TYPE 6R1 DIGITAL UNIT —SPURIOUS COUNT

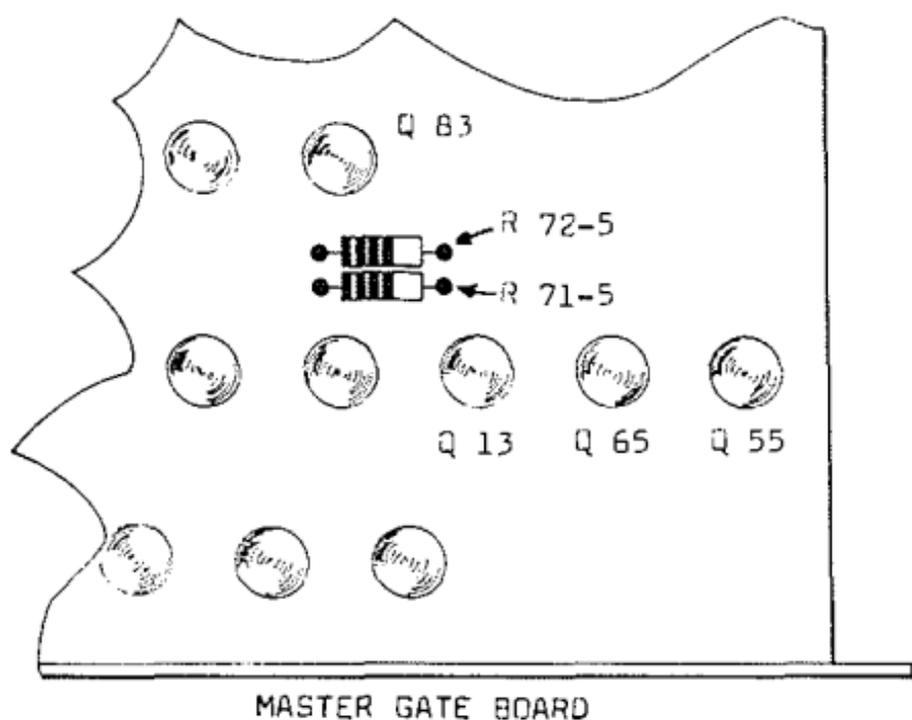
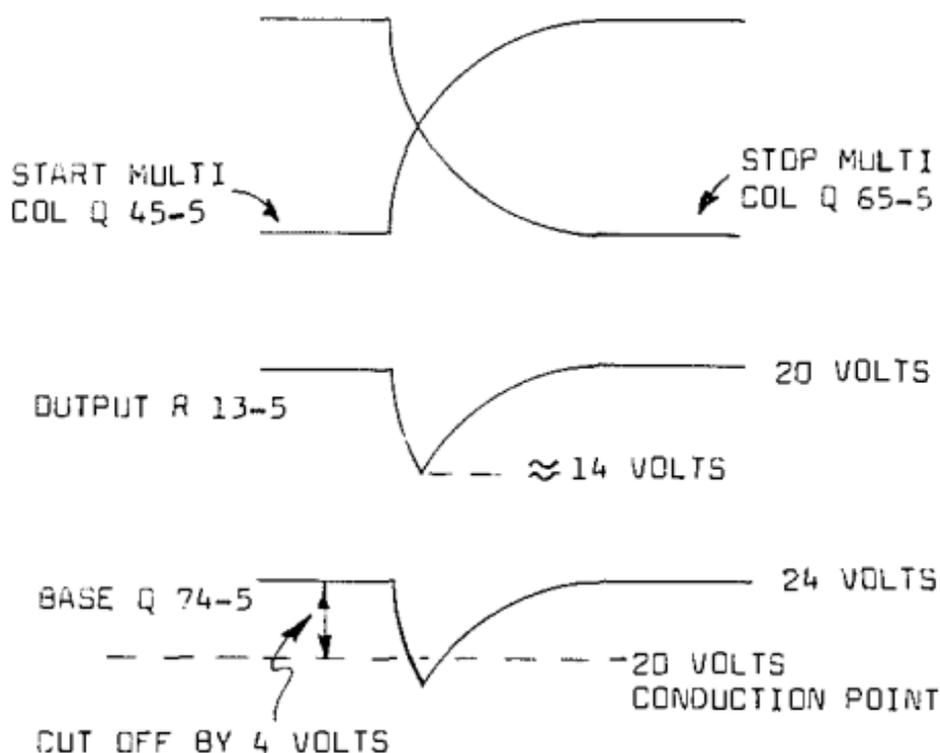
Type 6R1's employing a Model 2A, Series 5, Master Gate circuit board will produce a spurious (one extra) count during the reset phase of the Start and Stop multi-vibrators. This shows up when making voltage measurements with either a Type 3S76 Dual-Trace Sampling Unit or a Type 3S3 Sampling-Probe Dual-Trace Unit in the vertical plug-in compartment of the Type 567 Digital Readout Oscilloscope. It is most apparent when the MV/DIV control of these units is in any (except the most sensitive) "5" position.

This problem stems from the fact that

the Start multivibrator does not completely reset before the Stop multivibrator and produces a 6 volt negative pulse across the R13 resistor. The transistor Q74 is reverse biased by about 4 volts which is not enough to stop the 6 volt pulse. Changing the R72 resistor from 1 meg to 470 k raises the bias of Q74 to 9 volts enabling it to effectively block the 6 volt pulse and thus overcome the problem.

To correct this condition, — and we suggest here that you refer to the Master Gate schematic in the Type 6R1 manual — replace R72, a 1 meg, $\frac{1}{2}$ w, 5% resistor with a 470 k, $\frac{1}{2}$ w, 5% resistor (Tektronix part number 301-474).
